B Name of Land Development: Mount Saint Joseph's Academy - Building Connector - Phase 1

Reference: Mount Saint Joseph Academy – Land Development Application Review

Re: MCPC #23-0066-001
Plan Name: Mount St. Joseph's Academy Addition
(3,304 ft² institutional/2 lots comprising 77.07 acres)
Situates: West Wissahickon Ave (W), Stenton Ave (N)
Springfield Township

C3.0	SITE PLAN	 FRANCIS B. SHERIDAN GOVERNOR MONTGOMERY COUNTY, MARYLAND

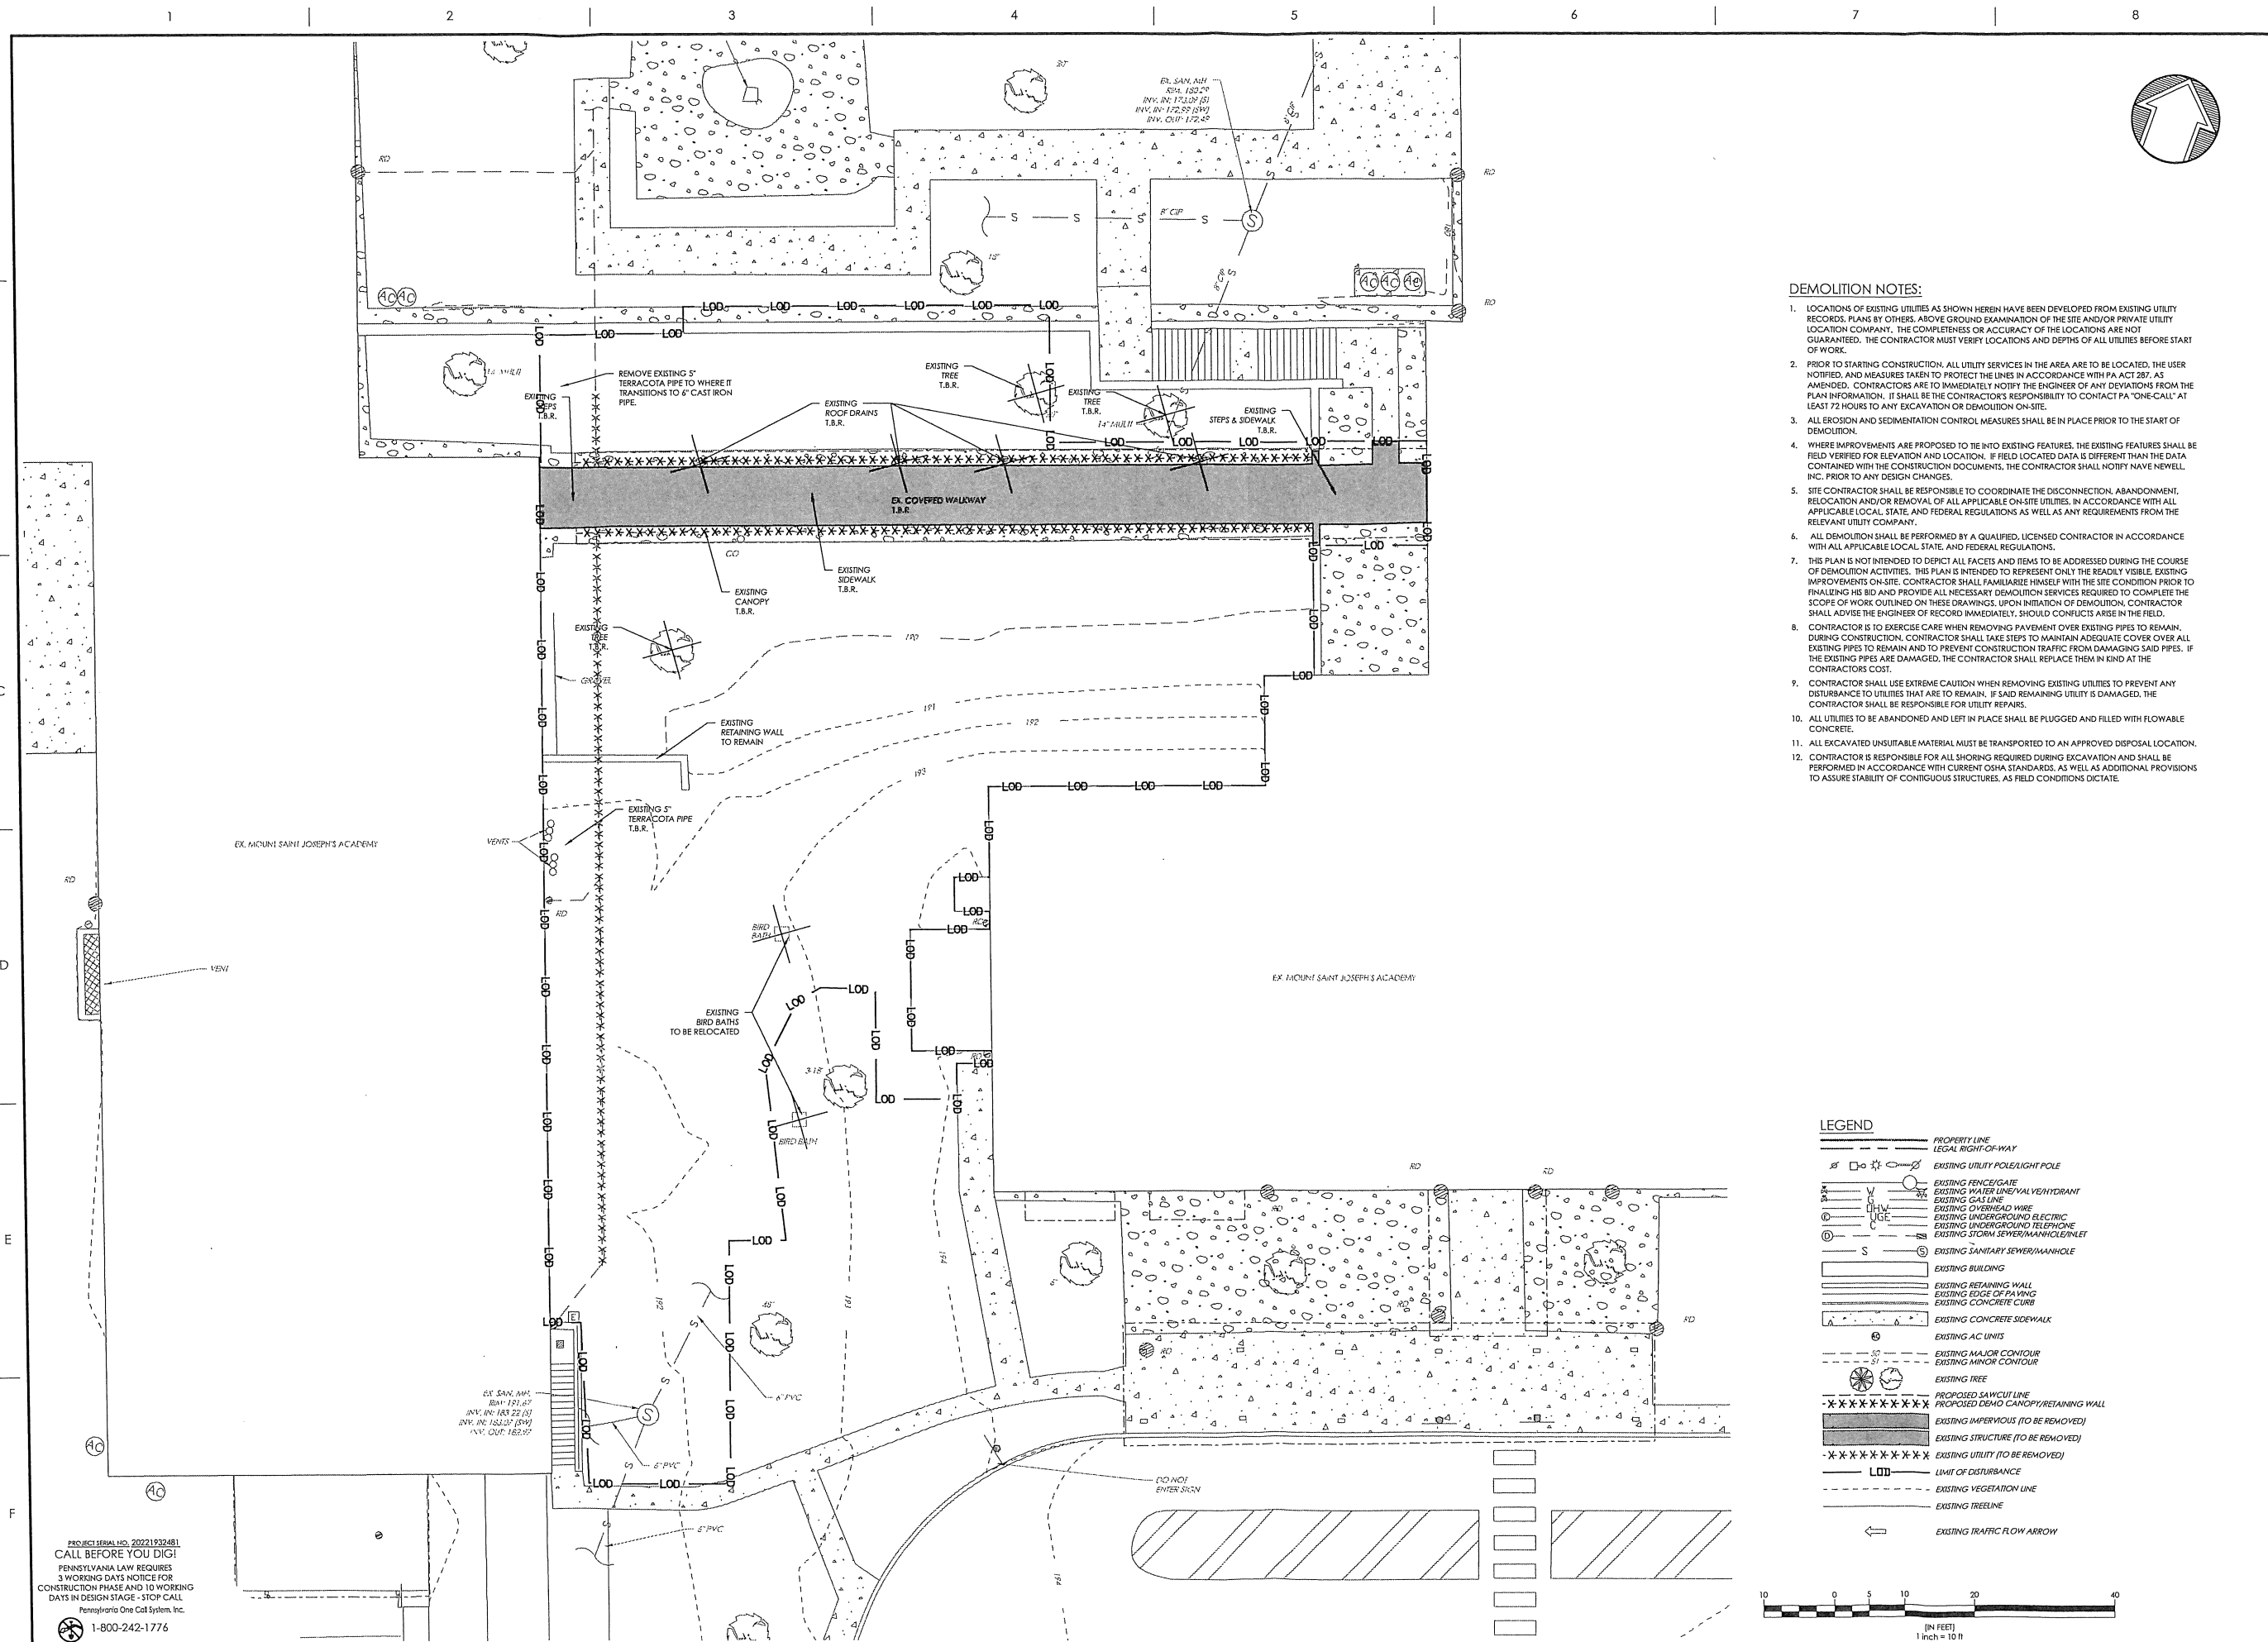
The zoning compliance chart on page C1.0 shows proposed impervious coverage as 19.10% by percentage, while the proposed impervious coverage is shown as 14.72 acres by acreage, or 19.51% coverage. The applicant should revise the compliance chart to address this discrepancy.

RAIN GARDEN DETAIL

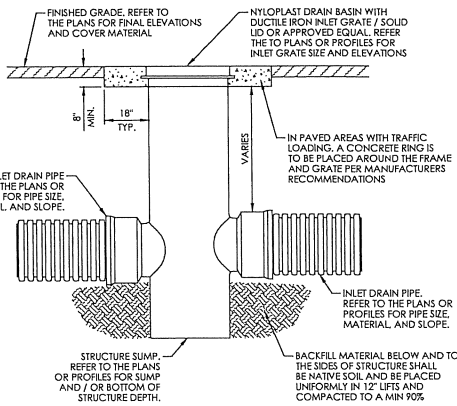
2. Section 95-7.H – A landscaping plan is required for the application. Specifically with this design, a more detailed description of the plant material to be utilized in the bottom of the proposed rain garden is required.

- A. Replacement of trees. Section 95-11(11)(c) requires the replacement of trees over three inches in caliper which are removed due to proximity to proposed structures. The replacement is required to be conducted at a rate of two new trees for each tree removed. The applicant should show the required replacement trees on the submitted land development plan, provide a fee-in-lieu of the required replacement trees, or request a waiver from §95-11(11)(c).
- B. Landscaping Plan. Section 95-7(H) requires that a landscaping plan be included among preliminary and final plans for all land developments. Given that the applicant proposes installation of a rain garden with amended planting soil, we recommend that the applicant submit a landscaping plan showing the species for planting in the rain garden or clarify that the rain garden will be planted with grass.
